SUBJECT: APPROVE CHANGE IN PROJECT SCOPE FOR THE SEISMIC RETROFIT OF THE MARSH DRIVE BRIDGE OVER WALNUT CREEK CHANNEL (PROJECT NO. 1854) AND TRANSFER IN LEAD AGENCY RESPONSIBILITY FROM THE CITY OF CONCORD TO CONTRA COSTA COUNTY; (FUNDED BY: STATE AND FEDERAL GRANTS AND GAS TAX)

**MARSH CREEK BRIDGE
OVER WALNUT CREEK CHANNEL
Project No.1854**

- i. Comment and Responses on Administrative Draft Feasibility Report

Figure 15 – Alternative 4 Retrofit with outrigger bents (Alternative 5 similar)

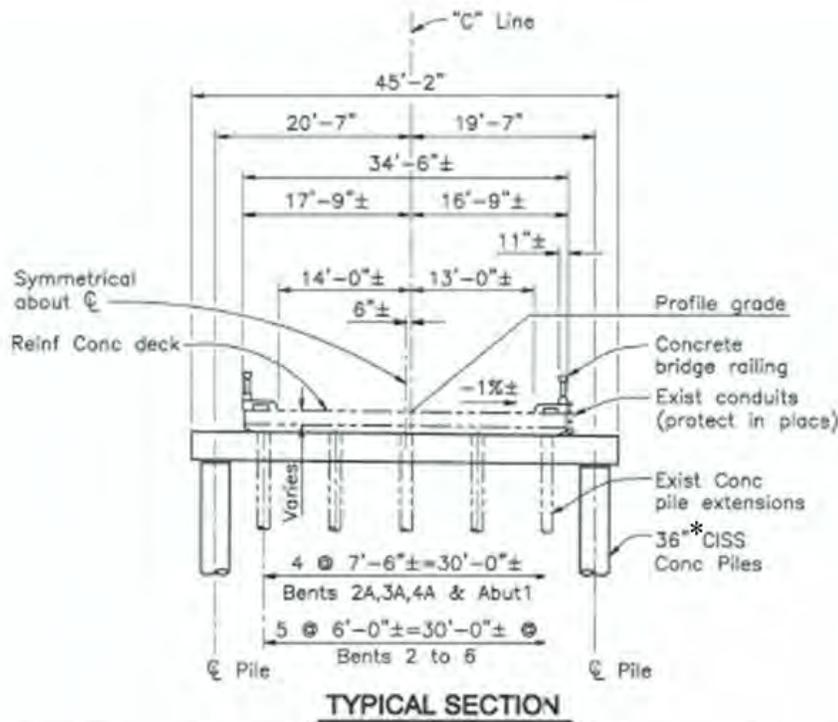
Page 16, Retrofit and Rehabilitation Alternatives	While Figure 14 is a typical section from the City's current retrofit plans set, the City has conveyed that they can provide 30-inch CISS piles to attempt to match the existing piles and reduce their hydraulic impact. Include a statement that reflects this information. Revise second sentence in the second paragraph, "It also creates an unacceptable backwater effect and increases the risk of flooding upstream. Any work within the channel will need to be approved by Army Corps of Engineers. The Flood Control District's experience with the Army Corps of Engineers is that any increase in water surface elevation is unacceptable and will need to be mitigated. This mitigation could include costly measures such as levee raising and additional channel work."	M	Added an asterisk to note the 30" piles. Added discussion on mitigations as commented.
Page 17, Cost	Revise first sentence to clarify that the estimated costs were developed for the alternatives based on the noted items that follow.	M	Revised as Commented

FILE NO. SHEET 3 OF 9

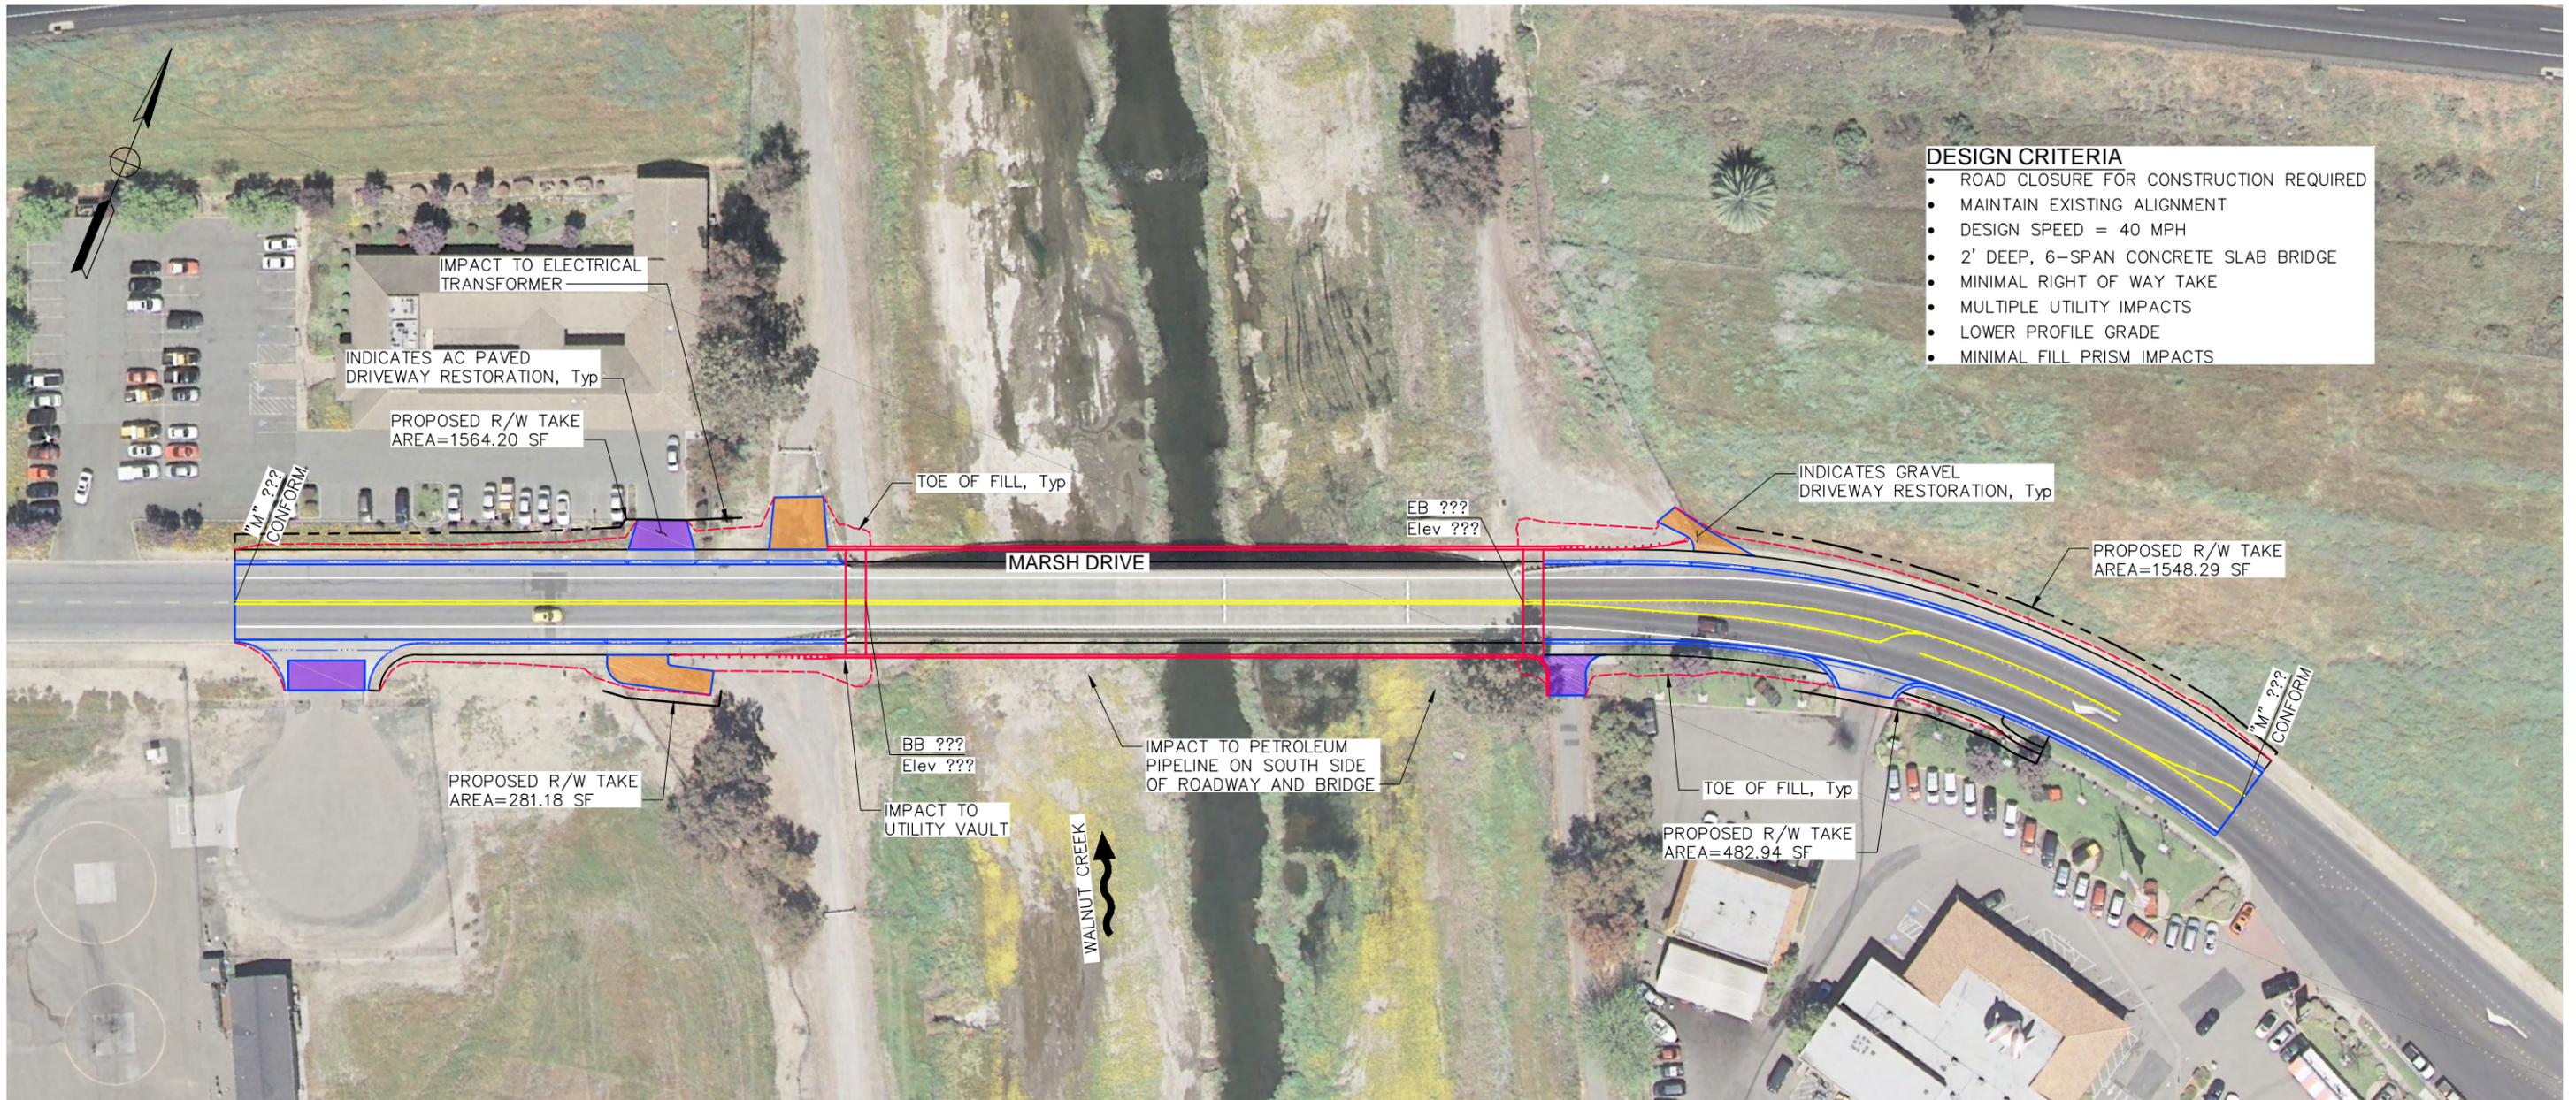
Sheet 3 of 9	The typical section appears to show a super elevated bridge deck. Revise slope arrow accordingly. This is consistent for all typical section on Sheets 3, 6 and 9.	M	Changed per comment

FILE NO. _____ SHEET 4 OF 9

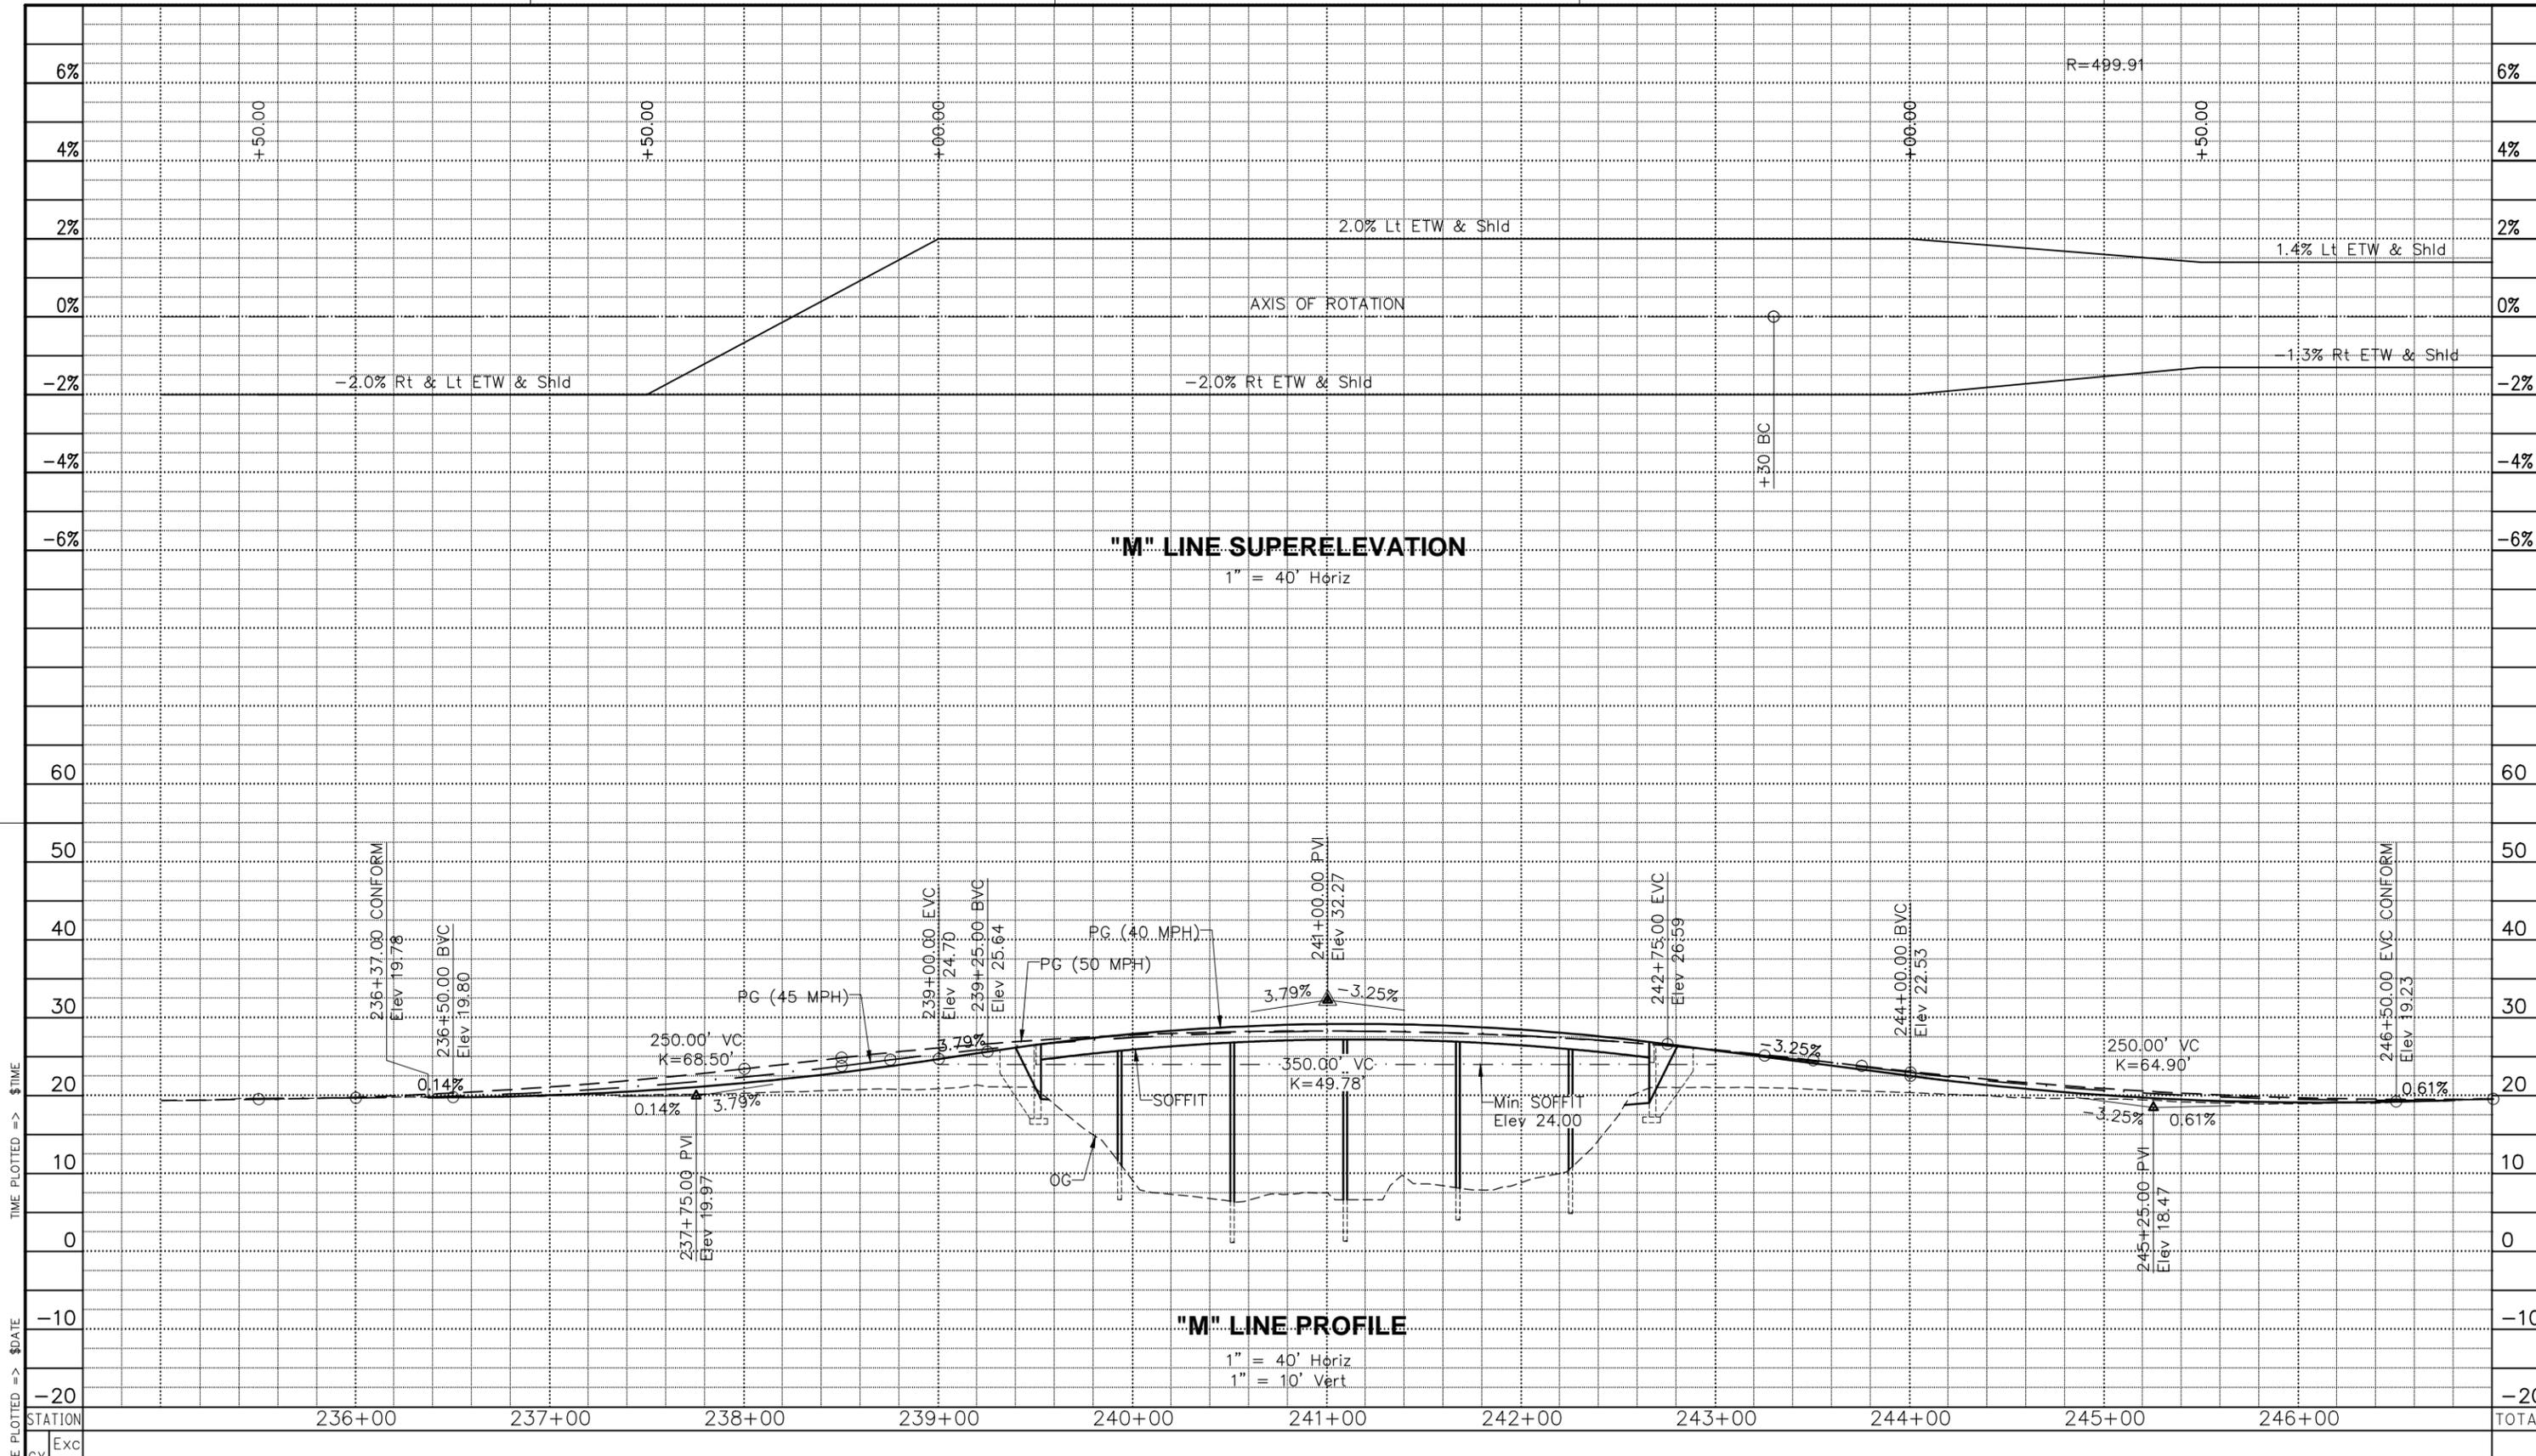
Sheet 4 of 9	Design Criteria states a 5-span concrete slab bridge, it should read 6-span per the profile on sheet 5.	M	Revised.
Cost estimates	Cost Summary; verify total for alternative 1 and 2. The number listed doesn't match other references to this total. Division II, Structural Items; footing types listed for alternatives 1, 2 and 3 indicate driven steel piles will be used. However, the plan sheets indicate that this will cast in drilled holes piers.		All cost estimates have been updated and verified. Cost estimates now reflect CIDH piling.
Life Cycle Cost Analysis report Page 1	Need and Purpose; replace 'Walnut Creek Bridge' with 'Marsh Drive Bridge over Walnut Creek Channel.'	M	Revised per Comment
Page 1,	Existing Bridge; Revise section to reflect latest bridge inspection report dated January 28, 2013.	M	Revised per Comment
Page 1,	History and Condition; Clarify seventh bullet point regarding load. Revise to state current bridge loading capacity less than current legal or permitted loads.	M	Legal loads are allowed and there is therefore no posting. Revised bullet point 7 be more clear

LIFE CYCLE COST ANALYSIS TIMELINE

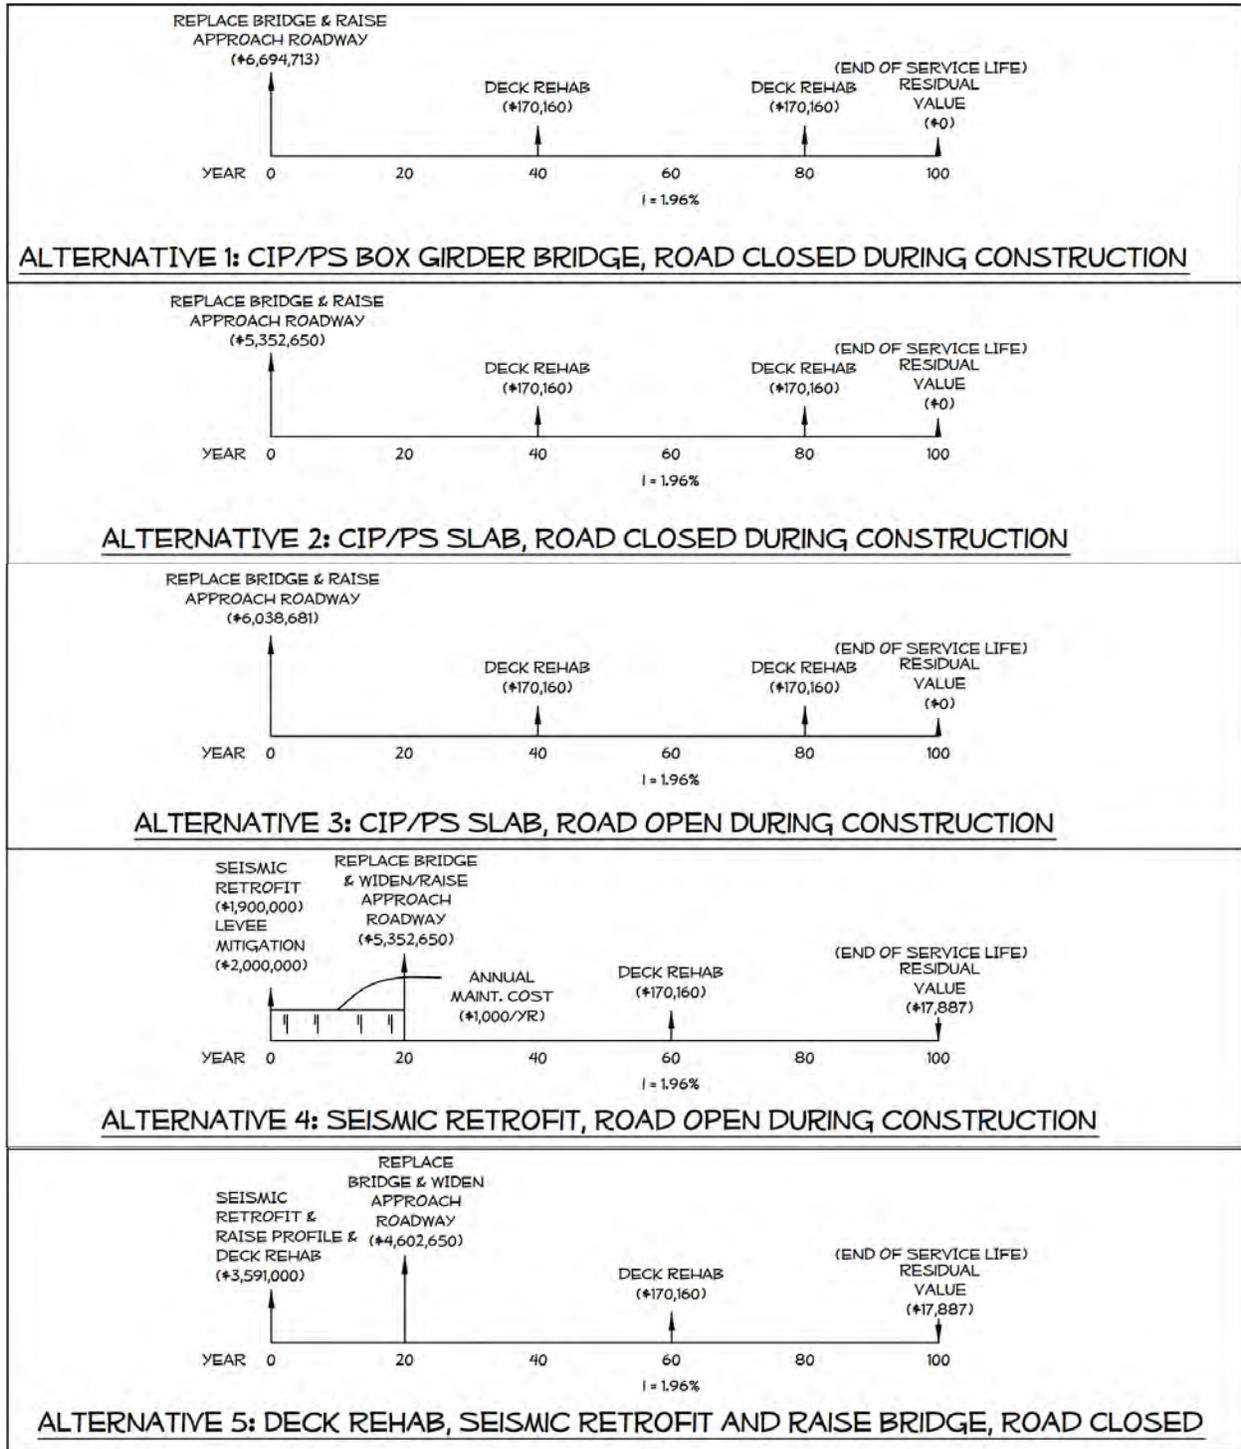
Page 8	Life Cycle Analysis Timeline; given the 120 year window of analysis, it appears that the analysis of retrofit alternatives 4 and 5 do not include a second bridge replacement. Without the costs of the second bridge replacement, the lifecycle costs identified in Figure 15, Alternative Comparison Table in the Feasibility Study Report imply that Alternative 5 is the least expensive option over the life cycle. Clarify in the narrative in both the Feasibility Study Report and Life Cycle Cost Analysis report that all costs do not include the same replacement actions.	S	Instead of clarifying the 120 year cycle, we have revised the cycle to 100 years. This way each alternative only has a single bridge replacement for the 100 year cycle.
